OSM/LUM DECISION SHEET (DSH)

Standard(s) (incl. year)	Subclause(s):	Tracking No.	Year
EN 60598-1:2015/A1:2018	4.11.3	DSH 0855A	2019
Category:			
LITE			
Subject:	Key words:	Developed by	Approved at
Electrical connections	<ul style="list-style-type: none"> - Construction - Connections - Locking device 	OSM/LUM-ETF5	2019 ETICS Plenary Meeting

Detail electrical/mechanical connection

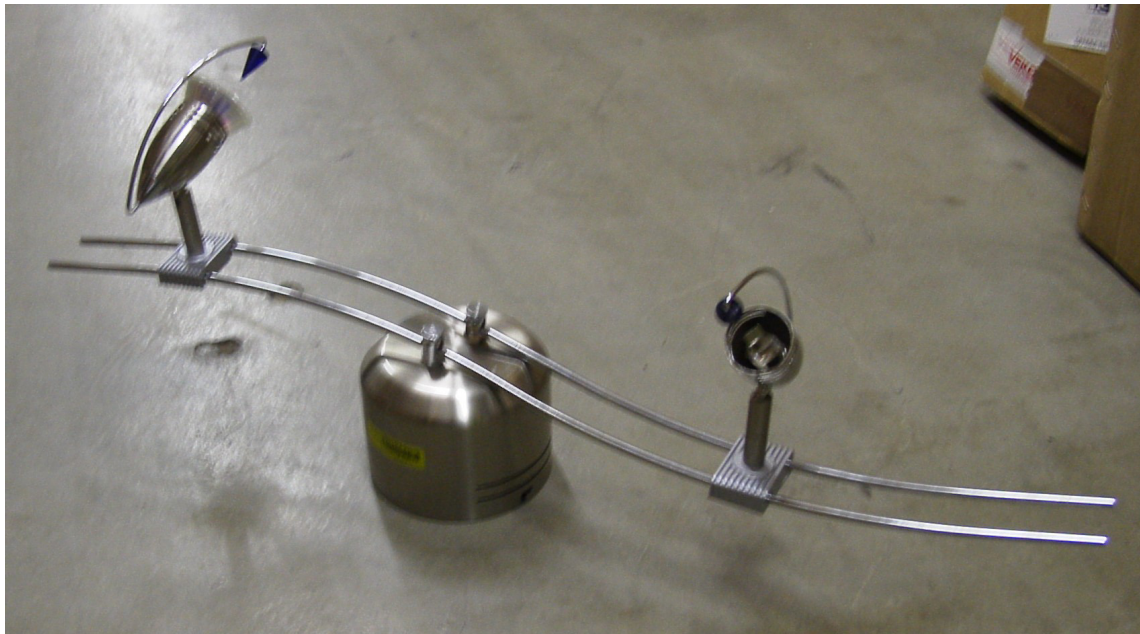
Screws, which serve as electrical as well as mechanical connections shall be locked against loosening. We have tested a decorative luminaire, consisting of a base part (containing a SELV transformer) and a track to which two luminaires are fitted. The track is fitted to the base by means of two screws, however the connection has no locking device and even this construction does not accept a locking device. Can we accept this connection or should we require a different construction?

This construction is not acceptable.
